Subject: UniStar Nuclear Energy, NRC Docket No. 52-016
Response to Request for Additional Information for the
Calvert Cliffs Nuclear Power Plant, Unit 3,
RAI No. 127, Circulating Water System

**Response to NRC Request for Additional Information
RAI No. 127, Questions 10.04.05-1A and 10.04.05-2B,
Circulating Water System, Calvert Cliffs Nuclear Power Plant, Unit 3**

RAI No. 127

Figure 1 – Sketch of the CWS Section View (Not to Scale)

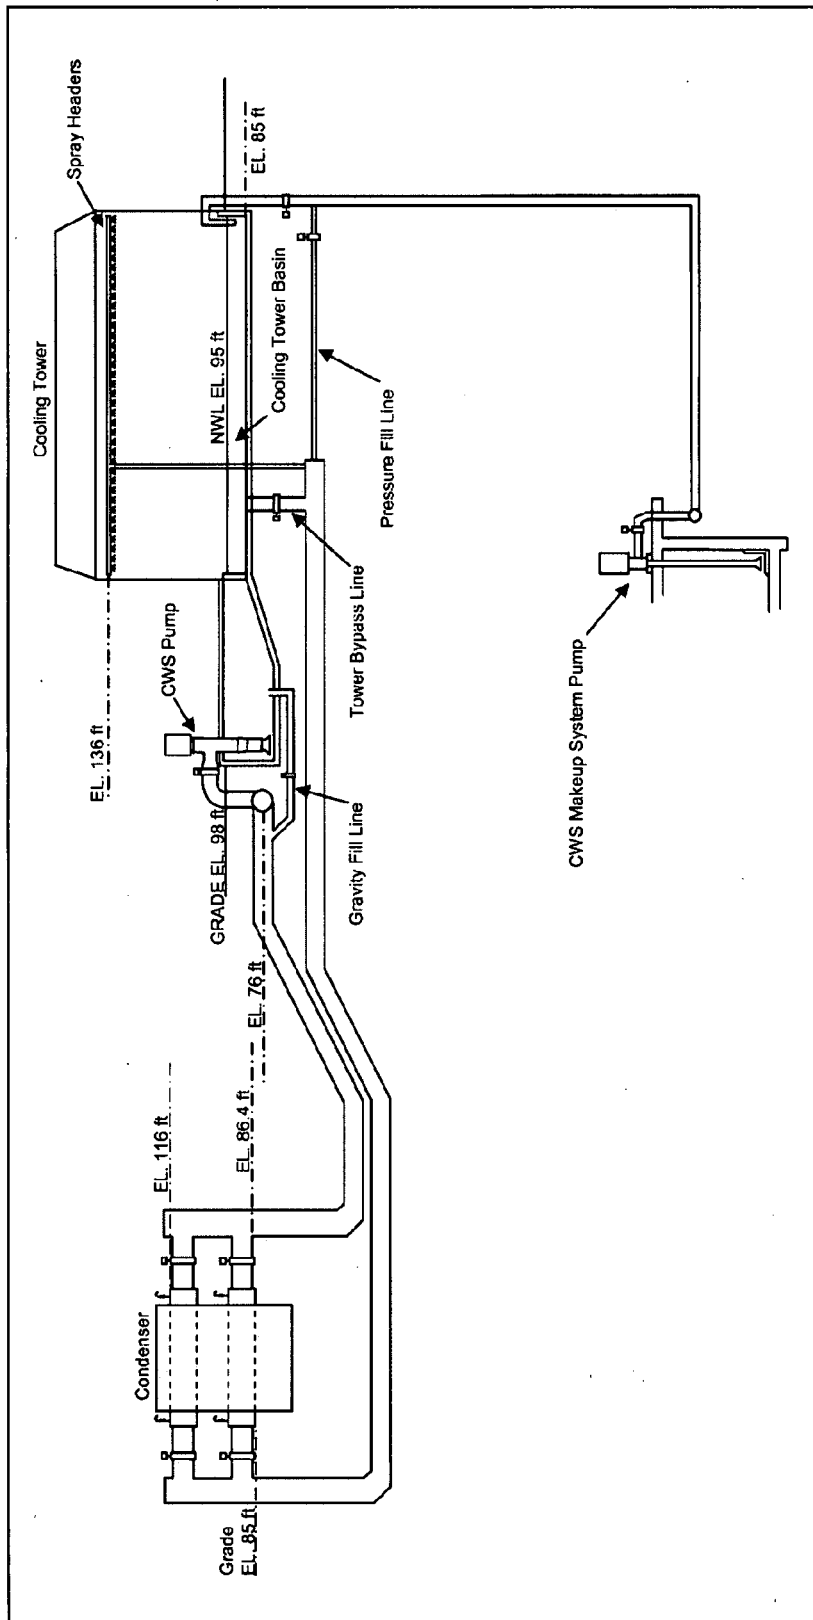
COL Information Item 10.4-6 for the CCNPP CWS states, "if a vacuum priming system is required, a COL applicant that references the U.S. EPR design certification will provide the site specific design information." In CCNPP Unit 3 FSAR Section 10.4.5.2.2, under "Vacuum Priming System," the applicant stated that a vacuum priming system is not required at CCNPP Unit 3; however, the applicant did not provide any justification for its statement. Therefore, the staff requests the applicant to provide additional information and/or clarification in this regard.

For the CCNPP Unit 3 Circulating Water System (CWS), a vacuum priming system is not required either for initial priming of the CWS in preparation for system startup or in maintaining system operation.

The CWS is filled and vented using gravity fill from the circulating water pump forebay and using the pressure fill line with the CWS makeup water system pumps (see Figure 1 below). First, the gravity fill line will be used to prime the Closed Cooling Water System (CLCWS) heat exchangers and fill a substantial portion of the condenser. During this operation, the circulating water makeup pumps provide water from the Chesapeake Bay directly to the cooling tower basin. Next, the pressure fill-line from the CWS makeup system will fill the remainder of the condenser and the rest of the CWS piping. The system is fully primed when fill water exits the condenser waterbox and CLCWS heat exchanger vent valves, and the cooling tower spray nozzles.

During normal system operation, either through the tower spray headers or the tower bypass line, the condenser and heat exchangers are under positive pressure. Therefore no vacuum priming system is required.
